**REVIEW OF REVISED SHELTER-IN-PLACE PLAN FOR THE MUSLIM SCHOOL
IN SANTA CLARA, CA**

Ramboll US Consulting, Inc. (Ramboll) has prepared this letter report to summarize our review of the revised Shelter-in-Place (SIP) Plan for the Muslim Community Association's (MCA's) Muslim School and associated religious facilities located at 3003 Scott Boulevard and 3080 Alfred Street in Santa Clara, California (the "Site").

Ramboll understands that the revised SIP Plan for the MCA campus is comprised of seven diagrams (see Appendix B), which are summarized below:

SIP-203

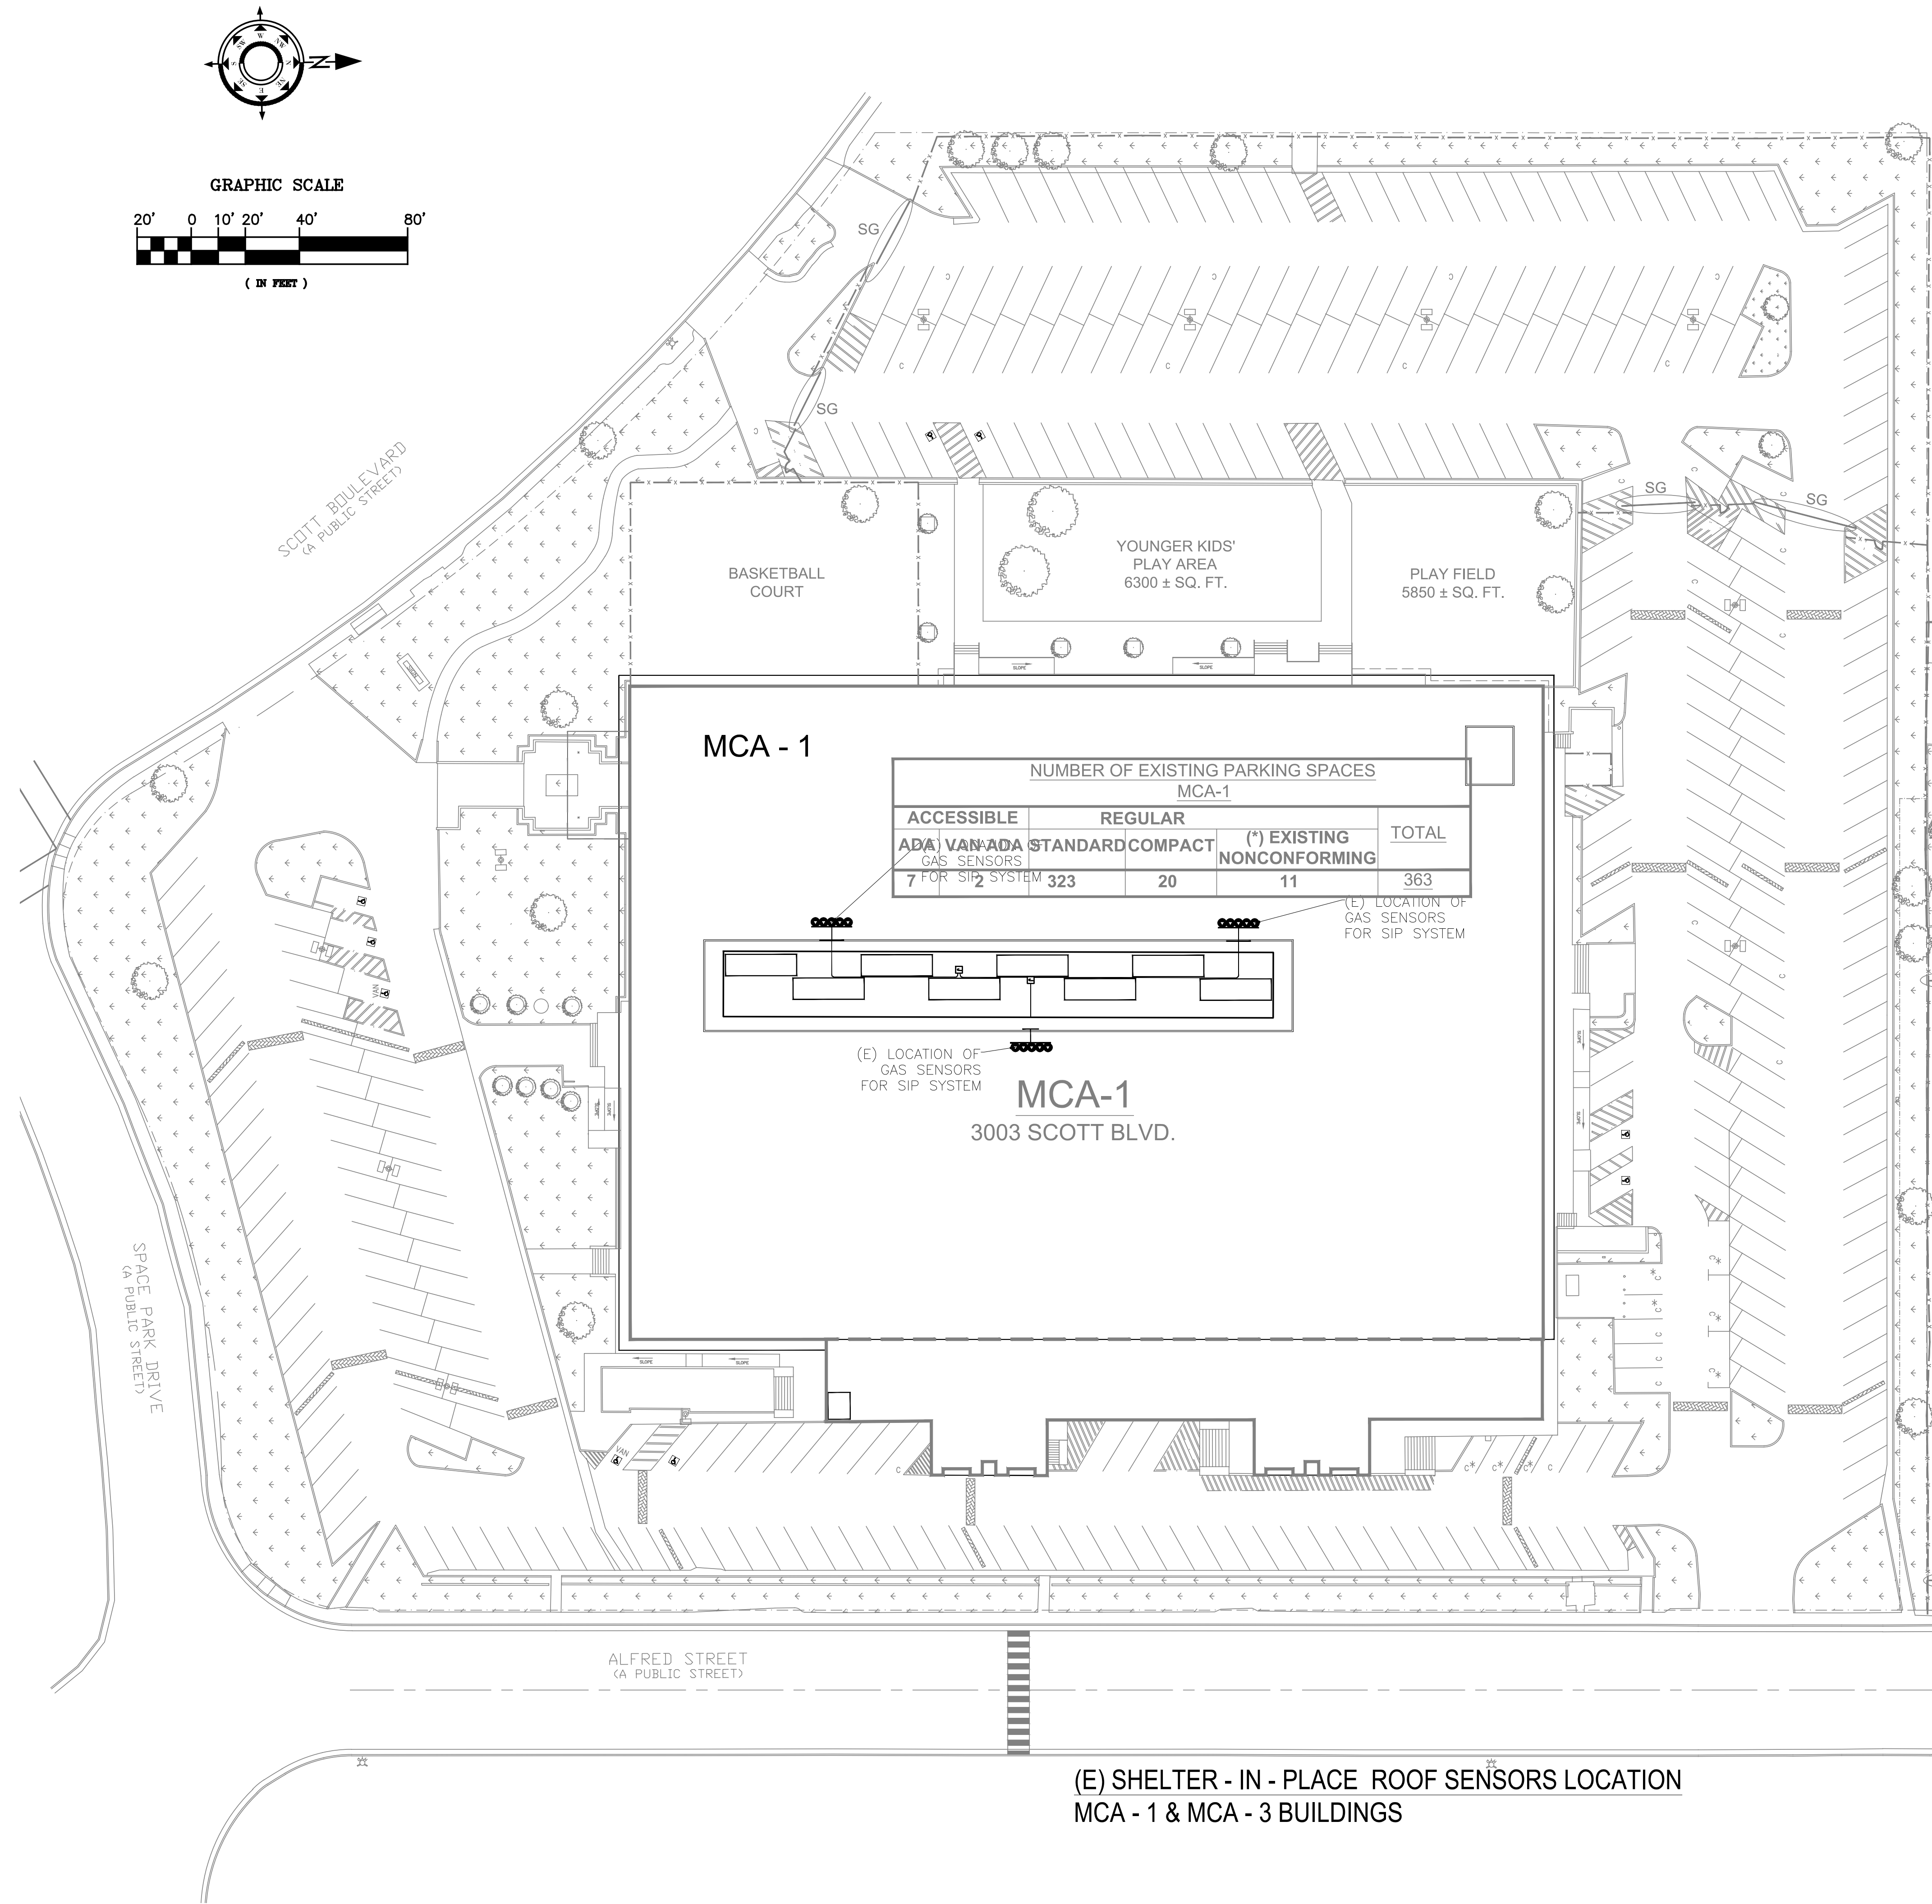
- The revised SIP Plan's descriptions of roles and responsibilities are consistent with local, state and federal guidance.
- The revised SIP Plan includes a table showing the roles and responsibilities for each member of the SIP Coordination Team (i.e., Sheet SIP-203). As indicated in the "Typical Notes" section, MCA should add the names of the Muslim School staff and MCA staff who have primary (i.e., "designated") and backup responsibility for each role. This table should be updated at least annually, when new team member(s) are added and when existing team member(s) change roles. A vacated designated team member position should be filled immediately by a backup team member on a temporary basis, with a permanent replacement for the designated or backup position being filled as soon as possible and no later than two weeks after the original position has been vacated.

- Ramboll recommends explicitly listing the responsibilities in the table in SIP-203, instead of (or in addition to) referring to the SIP Procedures for easier use of the table. In addition, it is not clear within the table, whether staff is designated for closing, locking, and sealing the exterior doors and posting the signs, shutting off the ventilation systems, and attending to the exposed individuals (if any). Ramboll recommends making these designations explicit.
